**Technical Service
Information Bulletin**

Title:
**TILT/TELESCOPIC STEERING
NOISE/SMOOTHNESS IMPROVEMENT**

Models:
'98 – '03 LX 470

**STEERING
ST002-04**

Steering
Column
Components

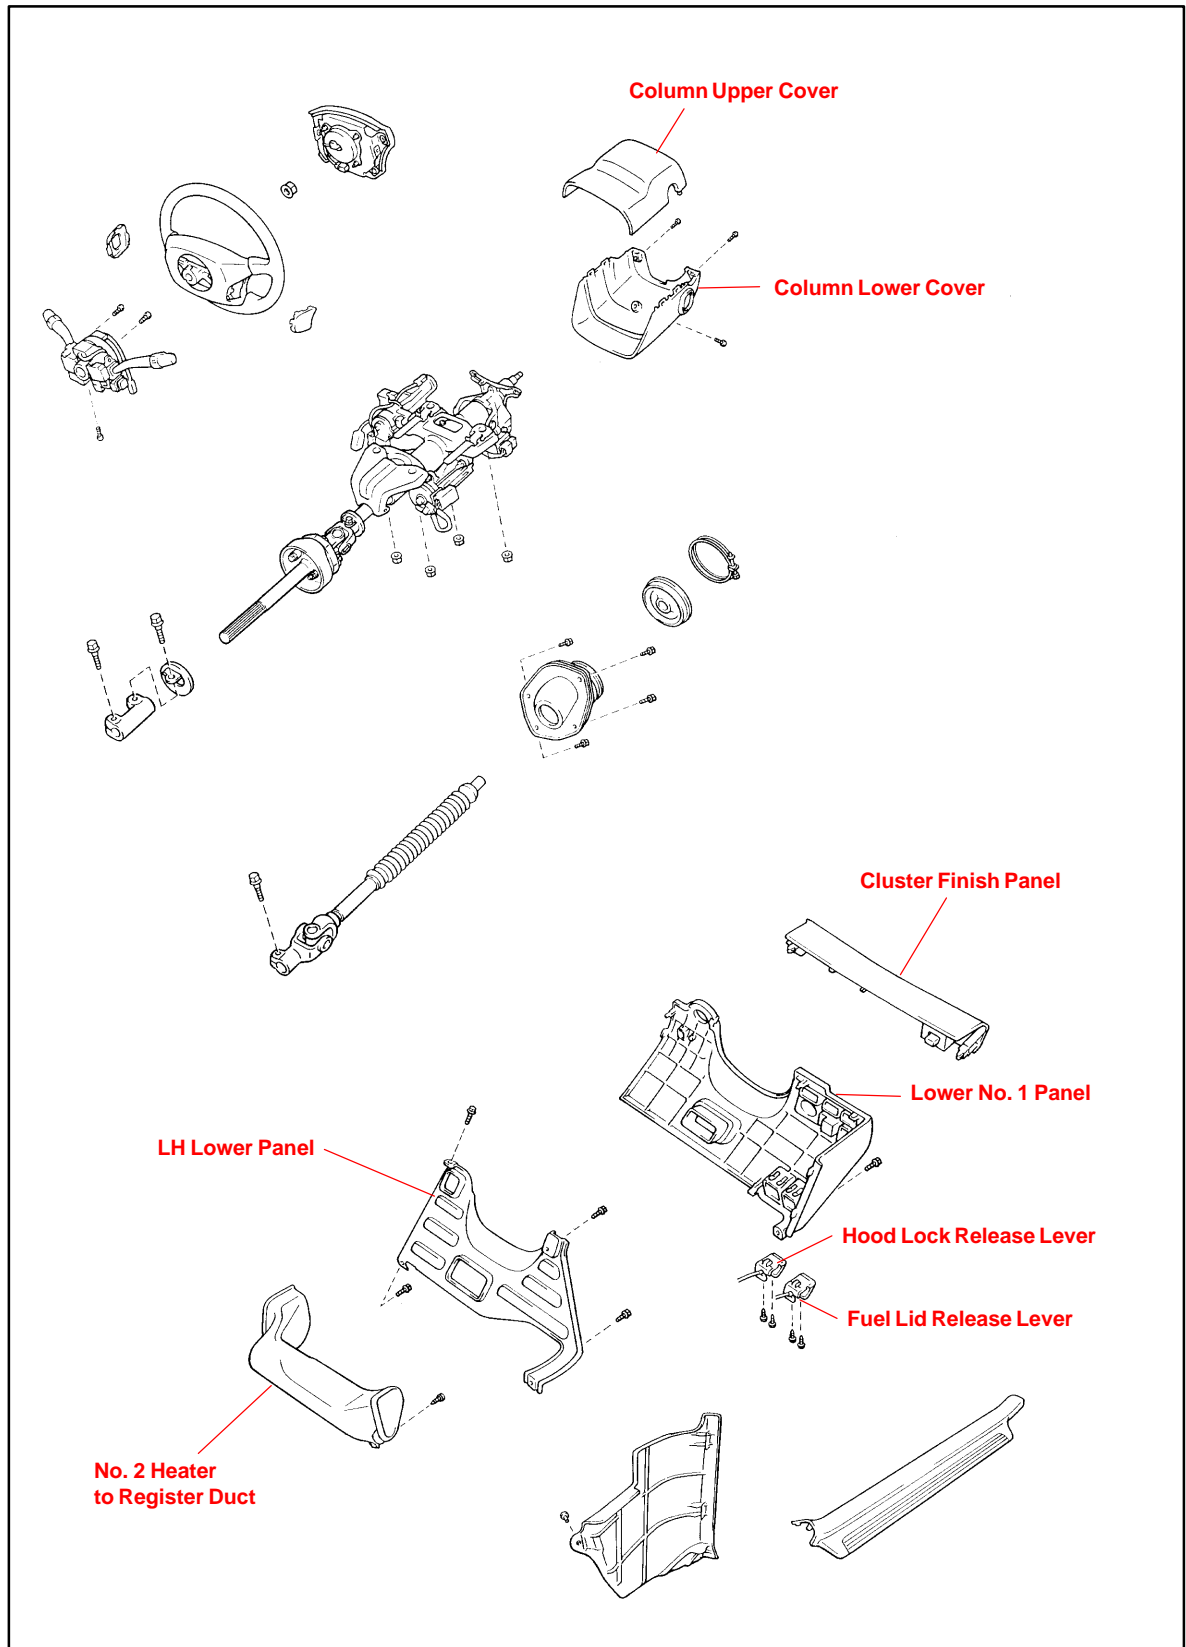
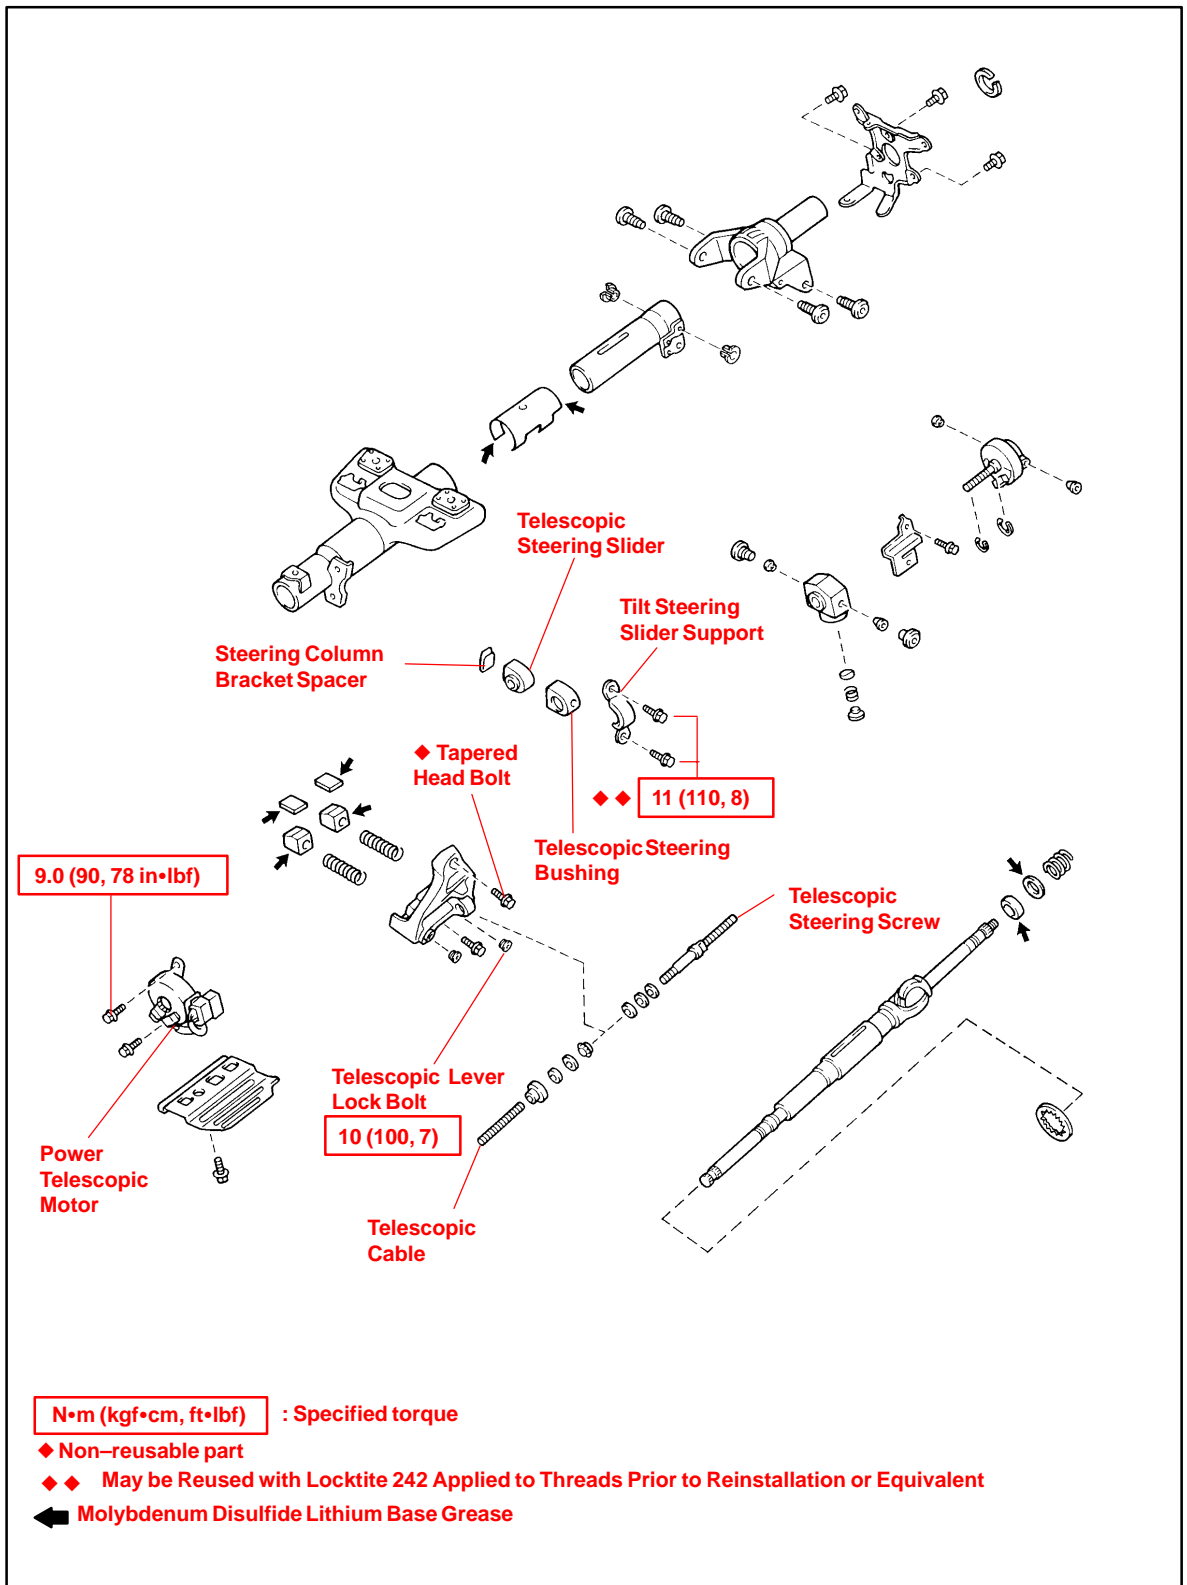
Introduction Some 1998 – 2003 model year LX470 vehicles may experience steering column noise. The cable has been replaced with a universal joint to reduce the steering column noise. Follow the repair procedures described below.

PROCEDURE PARTS	PREVIOUS PART NUMBER	CURRENT PART NUMBER	PART NAME	QTY
A	N/A	45230–50020	Joint Assembly, Steering Shaft Universal	1
B	45766–60011	Same	Support, Telescopic Steering Slider	1
	45898–60020	Same	Bolt, Support Stopper	2

**Repair
Procedure A**

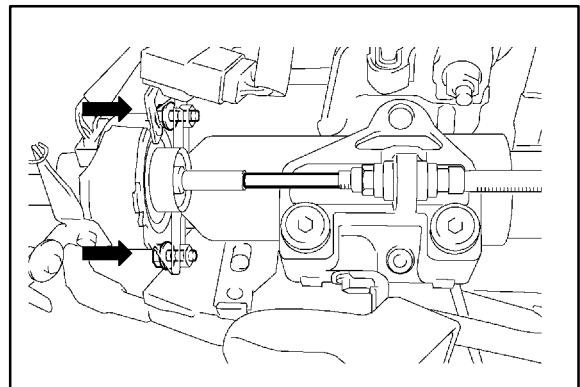
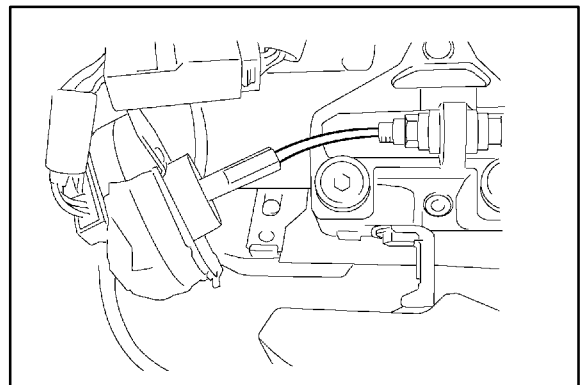
1. **Remove Power Telescopic Motor.**
 - A. Remove the 2 bolts and the power telescopic motor.

2. **Remove Telescopic Steering Column Cable Assembly.**
 - A. Remove the telescopic steering column cable.

**Repair
Procedure A
(Continued)**

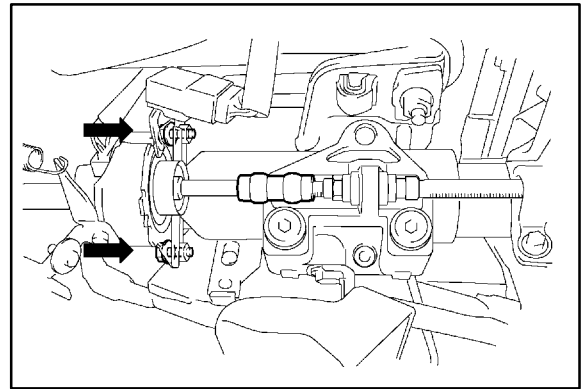
- 3. Install Steering Shaft Universal Joint Assembly.**
 - A. Install the steering shaft universal joint assembly.
 - B. Tighten the power telescopic motor with 2 bolts.

Torque: 9 N•m (90 kgf•cm, 78 in.•lbf)
